# Access Compliance Report

## Public Rights-of-Way

Intersection ID: 52622	Main Street: HERITAGE_POND_DR	Cross Street: ALEXANDER_COMMONS_DR	Location: N
ADA ID: B74F1E2B15BD	Ramp Type: Perp	Initial Pass/Fail: Fail	Overall Compliance: No
Severity Score: 26.25			
Codes/Mitigation Info/Possible Solution		Field Measurements/Component Compliance

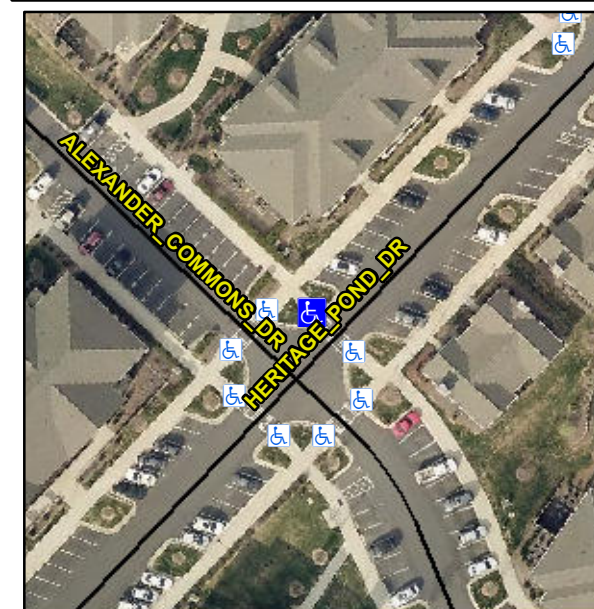
**Remove & Replace Entire Ramp.**

**R304.2.2, R304.5.3**

Compliance	Description	Data	Compliance	Description	Data
N/A	Ramp Length (in)	97.5	No	Ramp Slope (%)	15.0
Yes	Ramp Width (in)	81.5	No	Ramp XSlope (%)	2.8
N/A	Flare Type LT	N/A	N/A	Flare Type RT	N/A
N/A	Flare Slope LT (%)	N/A	N/A	Flare Slope RT (%)	N/A
N/A	Flare Traversable LT?	N/A	N/A	Flare Traversable RT?	N/A
N/A	Landing Length (in)	N/A	N/A	DWS Provided?	N/A
N/A	Landing Width (in)	N/A	N/A	DWS Contrast?	N/A
N/A	Landing Slope (%)	N/A	N/A	DWS Length (in)	N/A
N/A	Landing X Slope (%)	N/A	N/A	DWS Full Width?	N/A
N/A	Landing Curb? (Y/N)	N/A	N/A	DWS Offset (in)	N/A
N/A	Shared Landing?	N/A			
N/A	Gutter Ponding?	N/A	N/A	Gutter Slope (%)	N/A
N/A	Gutter Lip Ht (in)	N/A	N/A	Gutter X Slope (%)	N/A
N/A	Painted X Walk1?	Yes	N/A	Painted X Walk2?	N/A
	X Walk 1 Direction	To SE		X Walk 2 Direction	N/A
N/A	X Walk 1 Width (in)	88.0	N/A	X Walk 2 Width (in)	N/A
	X Walk 1 Slope (%)	3.8		X Walk 2 Slope (%)	N/A
	X Walk 1 X Slope (%)	0.4		X Walk 2 X Slope (%)	N/A
